**Si3402-A-GM to Si3402-B-GM EVB Modifications  
Version 0.4**

The Si3402-B-GM device requires component value changes from those used with the Si3402-A-GM evaluation board (EVB) reference design. Table 1 below is a summary of the required modifications.

Si3402 (Buck, Non-Isolated) EVB Reference Design - 5V

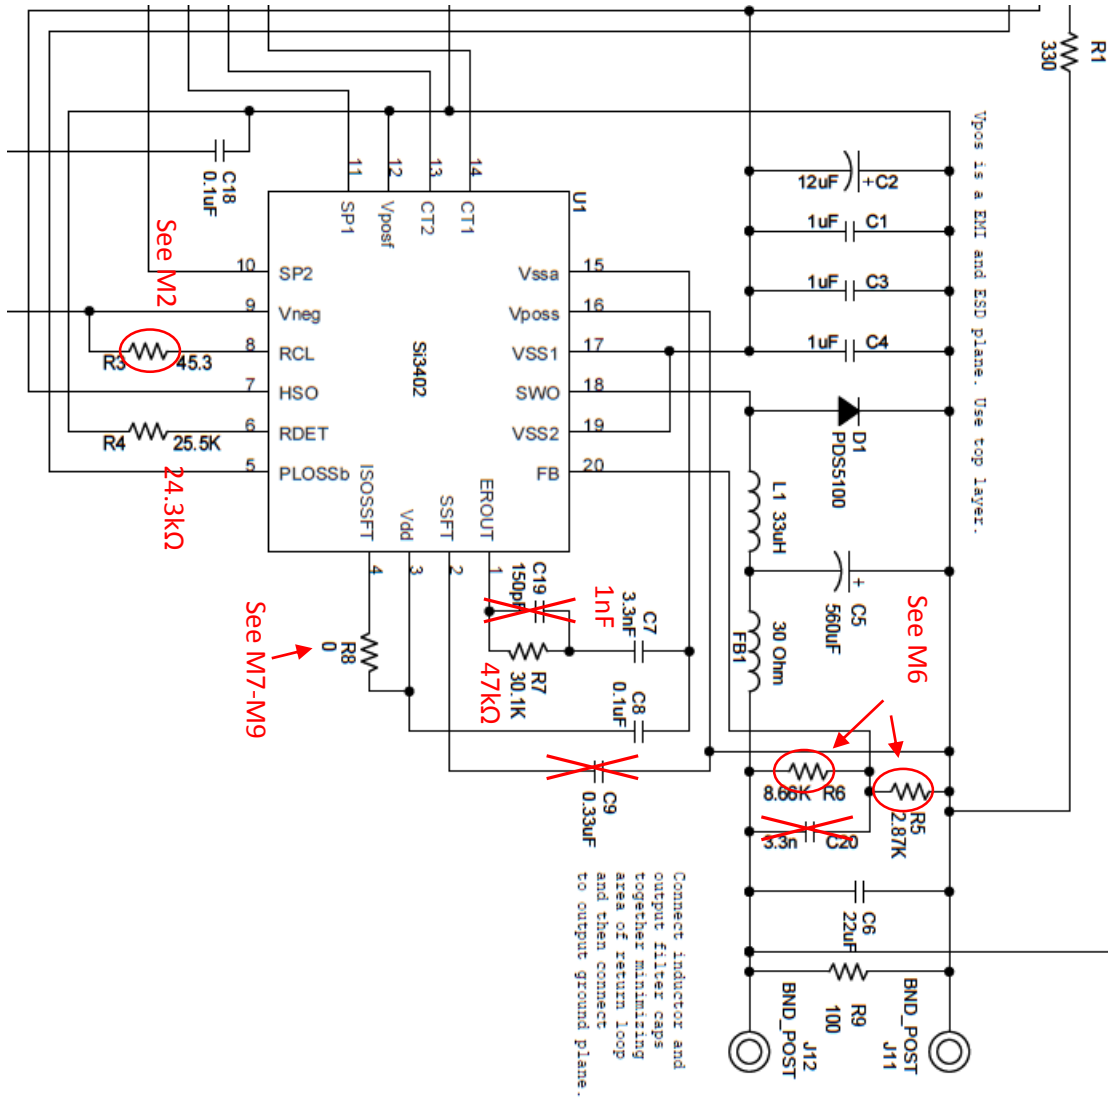
M6	DCDC reference voltage change (Buck case only)	Now 1.35V instead of previous 1.23V. Thus, R5 changes from 2.87kΩ 1% to 3.24kΩ 1%. R6 (1%) is modified according to this table:

Vout Target	R5 kΩ	R6 kΩ	Vref	Vout Measured
		3.3	3.24	4.64	1.35	3.37
		5	3.24	8.66	1.35	4.96
		9	3.24	18.2	1.35	8.93
		12	3.24	25.5	1.35	11.98
M7	BUCK EVB DCDC 3.3V compensation network changes	C19, C20 & C9 are not need—Do not populate them. R8 can be populated with a 0Ω resistor (creating a short between pins 3 and 4) or left unpopulated, since the ISOSSFT function is now internal (see datasheet). C7=1nF, R7=47kΩ ±20%.				
M8	BUCK EVB DCDC 5V compensation network changes	C19, C20, R8 & C9 are not need—Do not populate them. R8 can be populated with a 0Ω resistor (creating a short between pins 3 and 4) or left unpopulated, since the ISOSSFT function is now internal (see datasheet). C7=1nF, R7=47kΩ ±20%.				
M9	BUCK EVB DCDC 12V compensation network changes	C19, C20, R8 & C9 are not need—Do not populate them. R8 can be populated with a 0Ω resistor (creating a short between pins 3 and 4) or left unpopulated, since the ISOSSFT function is now internal (see datasheet). C7=1nF, R7=47kΩ ±20%.
